**SUBSURFACE WASTEWATER DISPOSAL SYSTEM APPLICATION** Maine Department of Human Services  
Division of Health Engineering, 10 SHS  
(207) 287-5672 Fax: (207) 287-3165

City, Town, or Plantation: **AUGUSTA**  
 Street or Road: **1673 TASKER ROAD**  
 Subdivision, Lot #: \_\_\_\_\_

SUBJECT: Approval, Replacement System Variance Request, Meyer property, Augusta

SITE PLAN:  
SCALE: 1"=50'

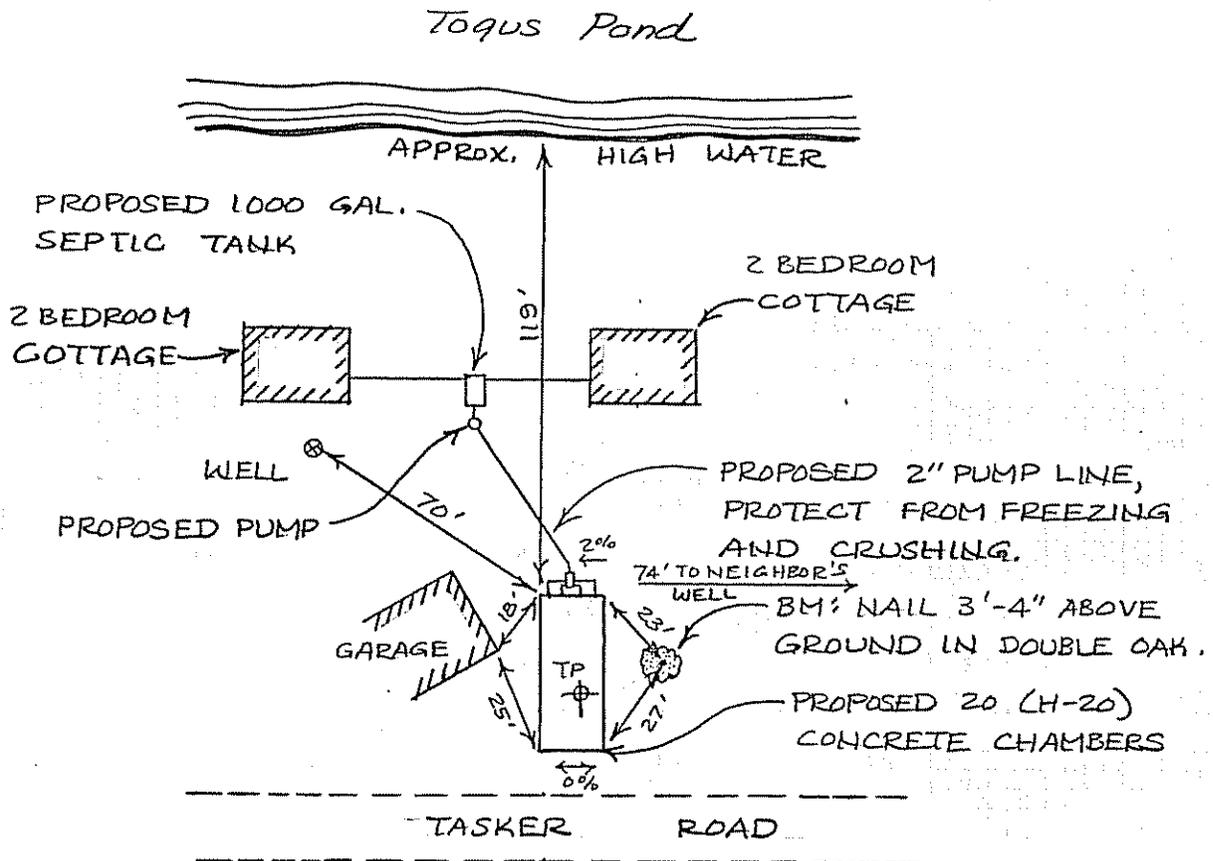
NEED AN EASEMENT FROM NEIGHBOR  
 TO PLACE THE SYSTEM 74' FROM  
 THEIR WELL.

The Division has reviewed a replacement system variance request for the subject property. The state variance requested is to install the system with a setback distance reduction from your well to the disposal field of 70 feet and to the septic tank of 50 feet, a setback distance reduction from a neighbor's well to the disposal field of 74 feet, and a setback distance reduction from a slab, frost wall, or columns to the disposal field of 8 feet. As we understand the situation, the variance request has been submitted because topography and existing development limit the potential system location. The system design prepared by Terry Adams, SE, dated 09/16/2005 is otherwise found to be in compliance with the Maine Subsurface Wastewater Disposal Rules.

We approve the requested variance with the following requirements:

- 1. A permit for system installation is to be obtained from the Local Plumbing Inspector in advance of the start of system construction.
2. The system is to be installed in accordance with the submitted and approved system design. Should alterations to the design be required at the time of construction, the site evaluator is to be notified prior to making any changes.
3. The contractor is to scarify the soils under the fill extensions to create a transitional zone more compatible with the disposal field area.
